PLANNING COMMISSION
SITE PLAN VARIANCE REQUEST REVIEW SHEET

CASE NUMBER: SP-2013-0295DS **PC DATE:** 12/9/2014

PROJECT NAME: 2908 Scenic Drive (Tram)

VARIANCE REQUEST: 1) To modify the standard 150-foot wide Critical Environmental Feature buffer in order to allow construction of a tram within a corridor 10 feet wide and 55 feet long that spans a canyon rimrock, Section 25-8-281(C)(1)(a).

SITE PLAN

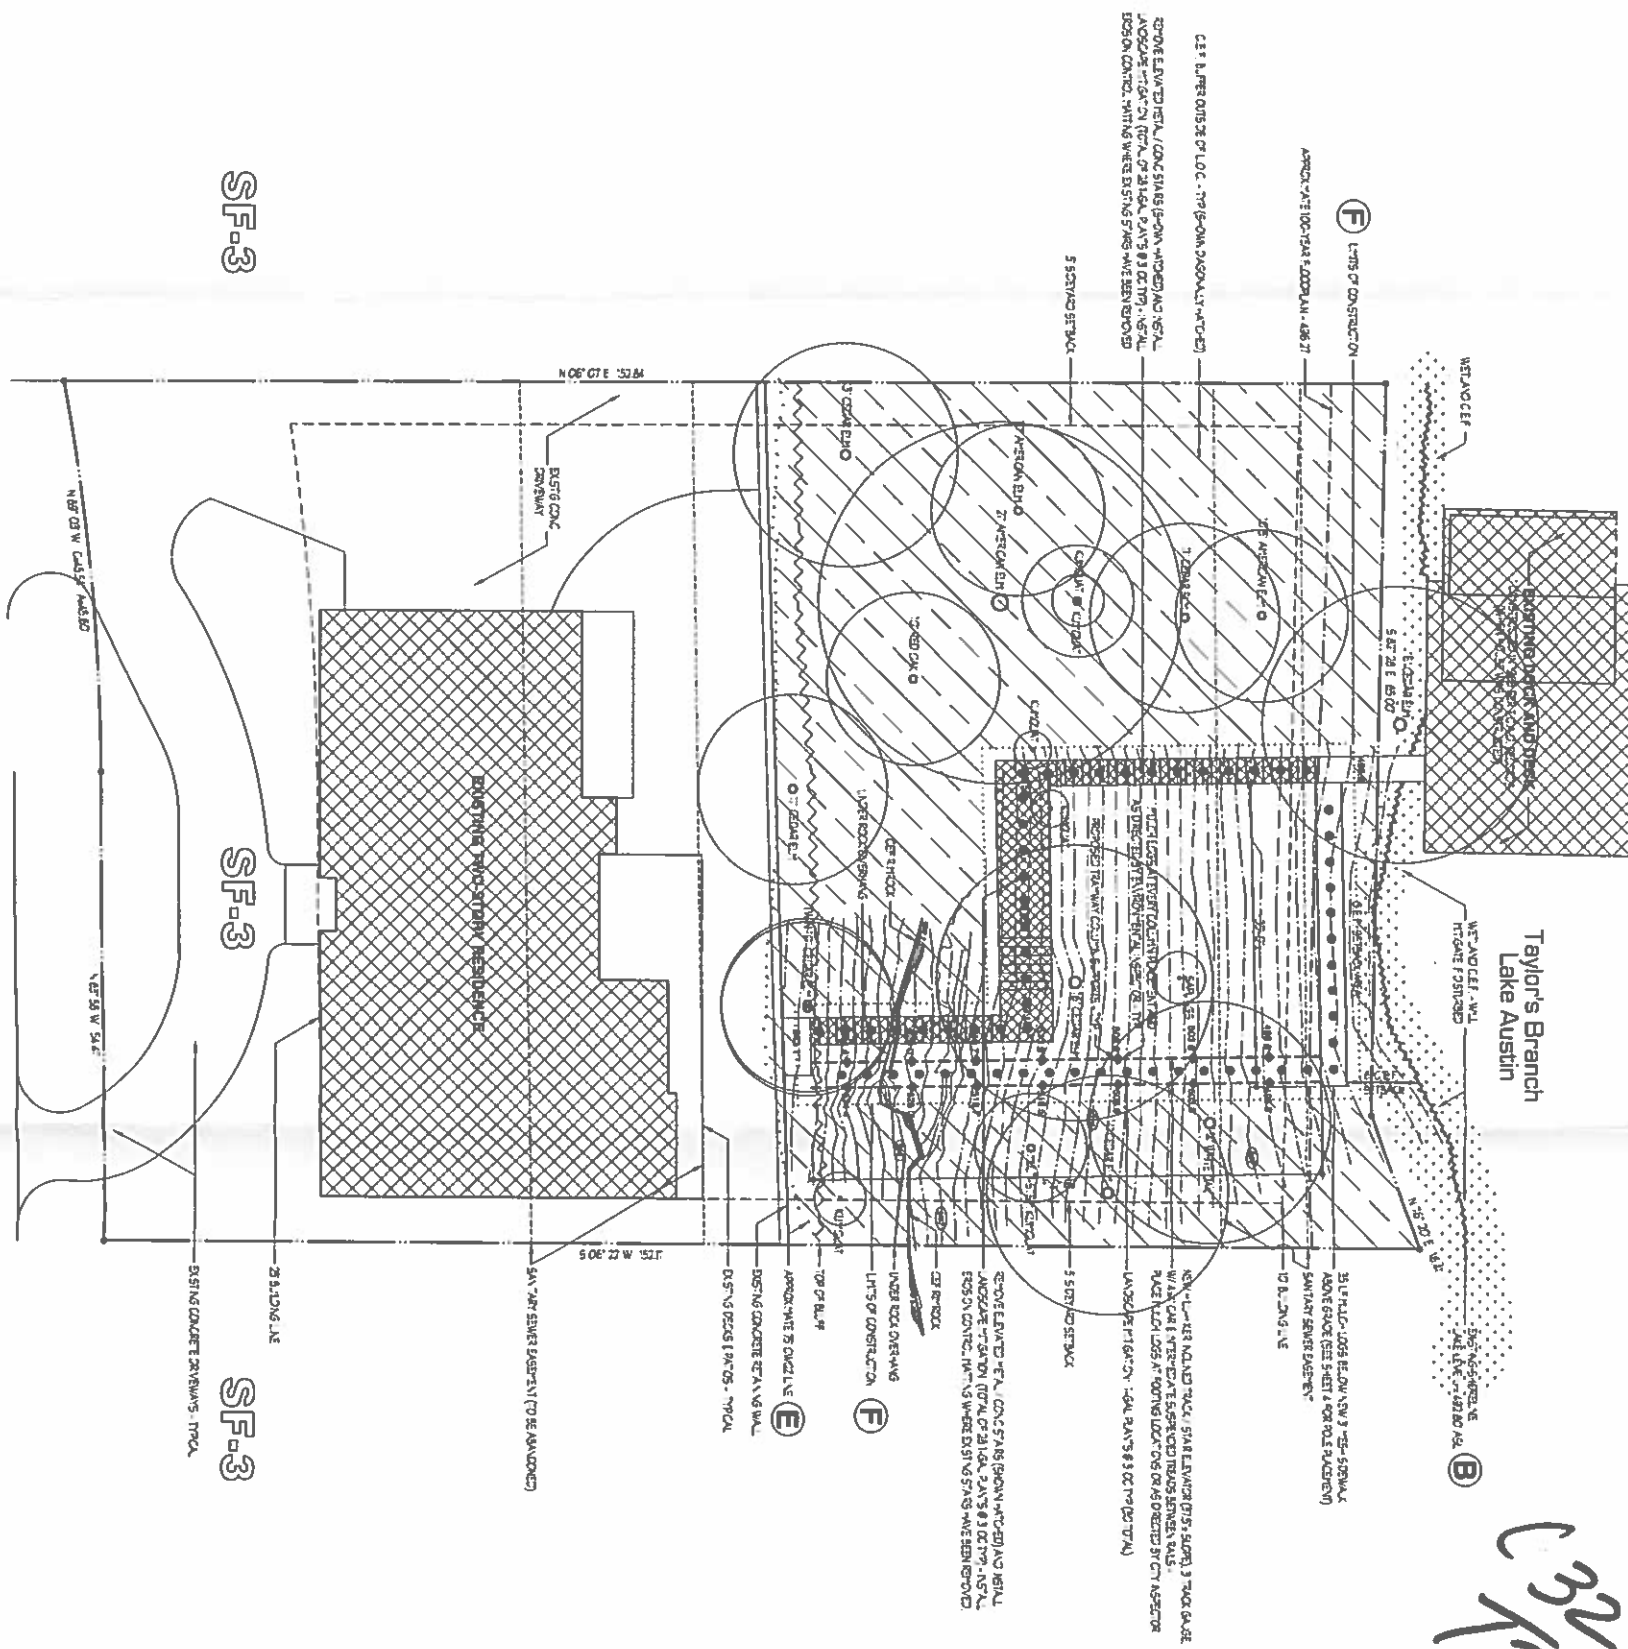
The site plan under review was submitted on August 1, 2013 and proposes the construction of a new tram and a walkway leading along the shoreline from the tram to the existing dock. The existing dock and associated existing stairs are proposed to remain. The applicant has agreed to construct a metal walkway leading from the tram to the dock with a metal mesh product, to help reduce the amount of disturbance along the shoreline and allow water and sunlight to infiltrate this area.

According to 25-8-281(C)(1)(a), a Critical Environmental Feature setback of 150' is required from the edge of the rimrock and 25-8-281(C)(1)(a) prohibits construction within the CEF buffer. The requested variance is to allow construction of a tram within the 150' buffer in order to allow the tram to cross over and span the rimrock. The canyon rimrock CEF will not be disturbed by tram construction. The existing shoreline access already crossed the rimrock and its buffer.

- Walkway leading from tram to dock will be constructed with metal mesh product.
- Applicant will restore all disturbed areas in the CEF buffer with native plants, per the approved site plan.

View of proposed tram route

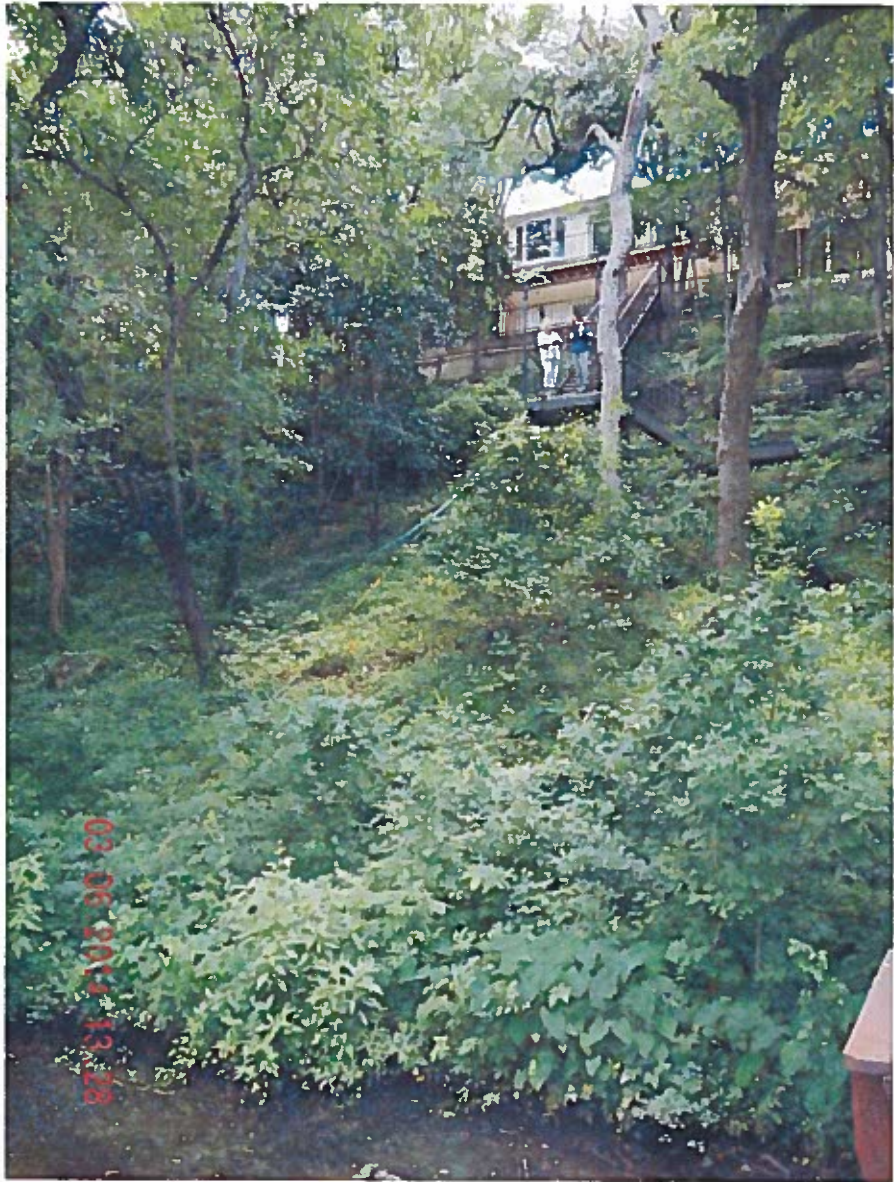
PREVIOUS REQUEST WAS TO KEEP EXISTING SHORELINE ACCESS

- Staff recommended denial of two variances: 25-8-261(C)(1) CWQZ for a secondary shoreline access, and 25-8-281(C)(1)(a) Critical Environmental Feature for reduction of a CEF buffer;
- EV Board recommended against the two variances on Sept 3, 2014 (5-2-0-0);
- Applicant has now agreed to remove existing shoreline access;
- Staff finds the single proposed access to be allowable within a CWQZ without an environmental variance;
- Due to the tram construction being minimal departure from the code, staff is now in support of the CEF variance request.
